**Classification of skin sensitizers using the results of local lymph node assays test methods
in accordance with OECD Test Guideline 442B**

Japanese response to the comments noted in the peer review report report for sub-categorisation based LLNA_BrdU-ELISA

Transmitted by the expert from Japan

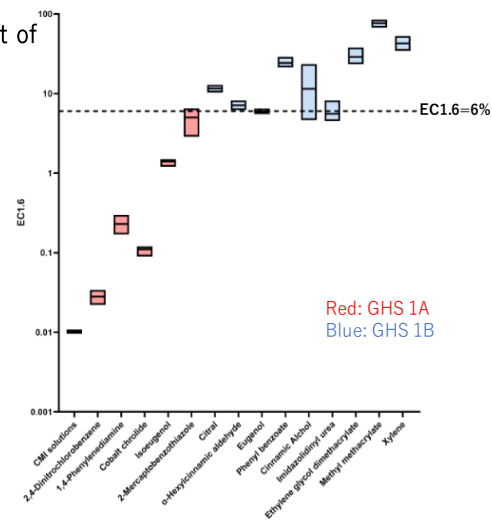
Comments (Paragraph No.)	Response to the PRP comments																		
<p>27. More importantly, some discussion of the potential for differences in the two nucleotide incorporation endpoints should be presented with respect to potential impact upon discriminating among skin sensitizers to justify the analyses.</p>	<p>Although both RI-LLNA and LLNA: BrdU-ELISA employ the same principle to measure the cell proliferation process by using incorporation of ^3H-thymidine or BrdU into DNA as indicators, the response curves of these methods are apparently different. And then, there is a difference in the detection process of cell proliferation; RI-LLNA directly detects the scintillation of ^3H-thymidine, whereas LLNA: BrdU-ELISA indirectly detects the chromogenic reaction of incorporated BrdU by immunochemical reaction using enzyme-labelled antibody. The difference of the response curves for these two methods was suggested to be caused by the deference of the detection process. However, the cut-off values for each method were determined based on the agreement between the EC values obtained by each method and the known classification results, so the classification performance of GHS1A/1B of these methods is suggested as the same.</p> <p style="text-align: center;">EP2 Effect of differences in the two nucleotide incorporation endpoints</p>

<p style="text-align: center;">Typical response curves of HCA</p> <ul style="list-style-type: none"> • The response curves are apparently different in these two methods. • Incorporation process of ^3H-thymidine and BrdU are the same. • RI-LLNA directly detects Scintillation counting of ^3H-thymidine. • LLNA: BrdU-ELISA indirectly detect incorporated BrdU by chromogenic reaction using immunochemical reaction of enzyme labeled antibody. • Although the differences in the response curve due to the detection process exist, this would not affect to the performance to categorize GHS 1A/1B because the cut-off % for each method was determined based on the agreement between the EC values obtained by each method and the known classifications results. 	Concentration (%)	HCA-BrdU SI value	HCA-RI SI value	0	1.0	1.0	5	1.2	1.5	10	1.8	3.0	20	2.5	6.0	25	2.8	-
Concentration (%)	HCA-BrdU SI value	HCA-RI SI value																	
0	1.0	1.0																	
5	1.2	1.5																	
10	1.8	3.0																	
20	2.5	6.0																	
25	2.8	-

EP3 the borderline results, impact of variability of individual animals

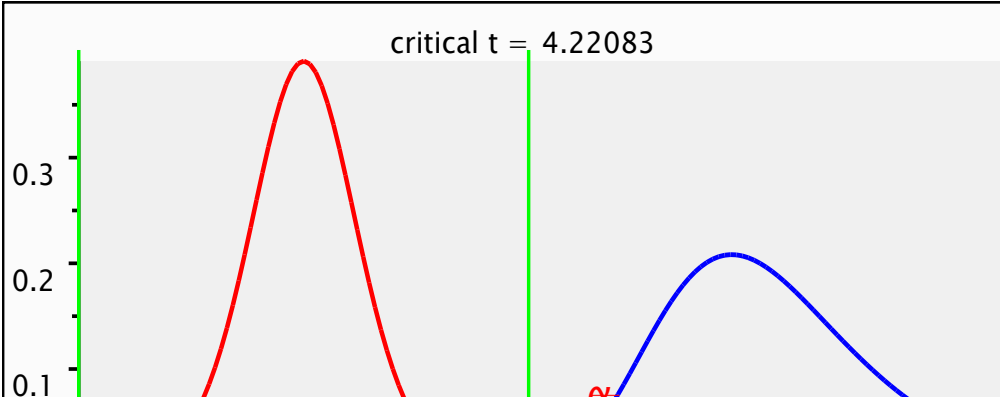
31. An analysis to determine the range of EC3 values for all of the substances near the putative cut-off should be conducted to best fit the available LLNA:BrdU-ELISA EC1.6 values with the ranges of RI-LLNA EC3 values.

Based on the data reported by Kobayashi et al. (2020), the maximum and the minimum EC1.6 values estimated from the upper and lower limits of the standard errors at the two data points used for calculating the EC values were plotted for 15 chemicals, and the impact of individual variation on the EC1.6 values was considered. Consequently, the estimated ranges of EC1.6 values were very narrow, then the impact of the variability of the individual animals on the final GHS1A/1B classification was considered as small.

To confirm the borderline results and individual variability of EC1.6, we tried to estimate the range of EC1.6 for the population from the standard error of the individual SI values in the CBA/J mice from the data used for the peer review.
